Redevelopment of Loreto Kirribilli School

*State Significant
Development
Modification Assessment
(SSD-7919-MOD-1)
September 2019*

Figure 15 | Modified Stage 1 western elevation with privacy measures (Source: Applicant's Modification Report)

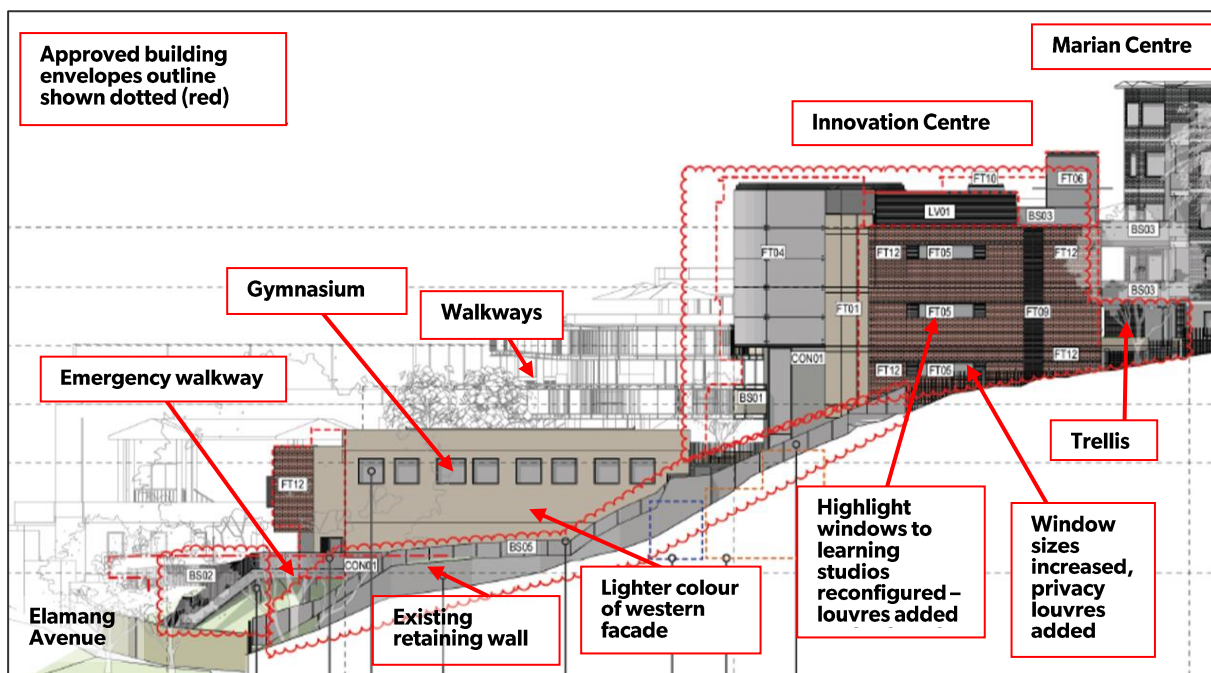
During the initial assessment of the modification application, the Department raised concerns regarding the adverse impacts of the habitable areas (learning studios / staff rooms) on the visual privacy of the adjoining residents. The Department also requested additional information on views to and from the modified windows.

In response, the Applicant amended the layouts of some upper level floors to include storage / workshop areas on the western elevation in lieu of the previously proposed habitable areas. The Applicant also submitted additional sight line diagrams to demonstrate that the proposed windows to the staff rooms at various floors would not directly face any of windows of residential units at 111 Carabella Street. Additionally, solid glass panels with louvres are proposed on these windows to mitigate any residual visual privacy impact on the adjoining residential development. The learning studios would include highlight windows only.
